**JULY 1, 2014 PLANNING COMMISSION HEARING
JULY 15, 2014 BOARD OF COMMISSIONER HEARING
“OTHER BUSINESS”
OPEN SPACE REVIEWS AND APPROVALS
COMMISSION DISTRICT 4**

ITEM OB-42

To consider approval of an R-20 Open Space Community Overlay application for Landgroup Group Atlanta, Inc. regarding Application OSC 14-01 filed May 5, 2014, for property located at 76 Cooper Lake Road; in Land Lot 250 of the 17th District, Cobb County, Georgia.

PETITION NO.: OSC 14-01

76 COOPER LAKE ROAD PROPERTY
 ZONING PLAN FOR: LAND LOT 250
 LOCATED IN: COBB COUNTY, GEORGIA
 17TH DISTRICT, 2ND SECTION

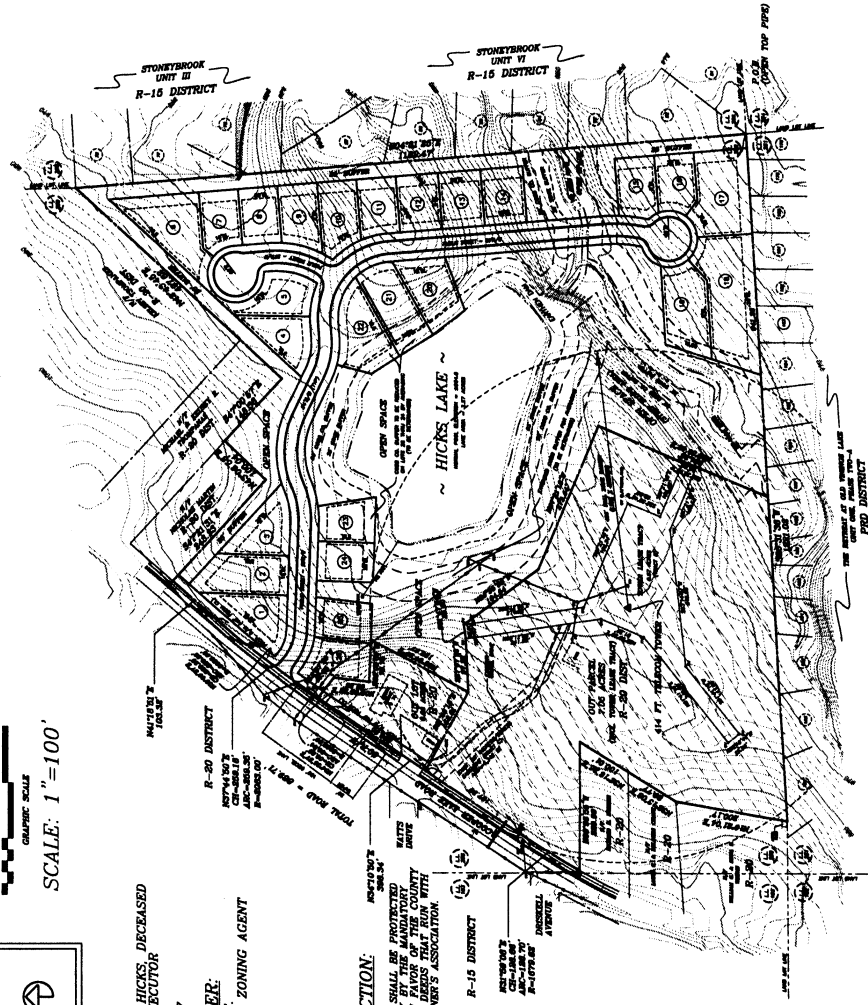
1. All required stream buffers must be within open space. This includes lots 18, 19, 20, 21, 22, 23, & 24. Seven lots encroach into required stream buffer.

3. Overall residential development shall be compatible with neighboring residential uses. In areas where adjoining neighborhood lots are larger than those proposed (i.e. lots 6 – 17) the plan should incorporate larger lots adjacent to existing neighborhoods with smaller lots designed to the interior.

- FEMA Designated 100 year Floodplain Flood.
- Flood Damage Prevention Ordinance DESIGNATED FLOOD HAZARD.
- Project subject to the Cobb County Flood Damage Prevention Ordinance Requirements.
- Dam Breach zone from (upstream) (**onsite**) lake - need to keep residential buildings out of hazard.

- Provide comprehensive hydrology/stormwater controls to include development of out parcels.
- Submit all proposed site improvements to Plan Review.
- Any **spring activity** uncovered must be addressed by a qualified geotechnical engineer (PE).
- Structural fill _____ must be placed under the direction of a qualified registered Georgia geotechnical engineer (PE).
- Existing facility.
- Project must comply with the Water Quality requirements of the CWA-NPDES-NPS Permit and County Water Quality Ordinance.
- Water Quality/Quantity contributions of the existing lake/pond on site must be continued as baseline conditions into proposed project.
- Calculate and provide % impervious of project site.
- Revisit design; reduce pavement area to reduce runoff and pollution.

- No Stormwater controls shown _____
- Copy of survey is not current – Additional comments may be forthcoming when current site conditions are exposed.
- No site improvements showing on exhibit.

1. The underlying zoning density and lot yield plan assumes that the existing lake will be drained and detention provided elsewhere on the site. However, no consideration has been provided for the stream buffer that would be reestablished through the existing lake to the upstream springhead. This would most likely eliminate Lot 15.
2. The proposed OSC layout has allowed for the undisturbed stream buffers that exist on the site, but not for the 25-foot additional impervious setback from the undisturbed buffer. The impervious setbacks will make lots 19, 20, 22 & 23 unbuildable and likely impact lots 18, 21 & 24.
3. The dam and outlet control structure(s) will be required to be brought up to existing County design standards.

- D. It is Staff's opinion that the applicant's proposal is in conformity with the policy and intent of the *Cobb County Comprehensive Plan*, which projects this site to be within the Low Density Residential area with densities ranging from 1 to 2.5 units per acre. The proposed development has a density of 1.56 units per acre. However, the applicant's proposal is not in conformity with the *Open Space Community Overlay Ordinance*, which states that all required stream buffers should be within the open space. In addition, Stormwater Management comments suggest applicant needs to provide an additional 25' impervious buffer on site plan to adequately determine affected lots.

- E. It is Staff's opinion that there are existing and changing conditions affecting the use and development of the property to give supporting grounds for not approving the applicant's proposal. The Open Space Community Overlay district strictly prohibits individual lots within stream buffers and mandates all required stream buffers to be within the required Open Space. In addition, Staff has not been given the opportunity to fully provide an adequate analysis due to required information that is missing from site plan stamp dated received May 12, 2014.
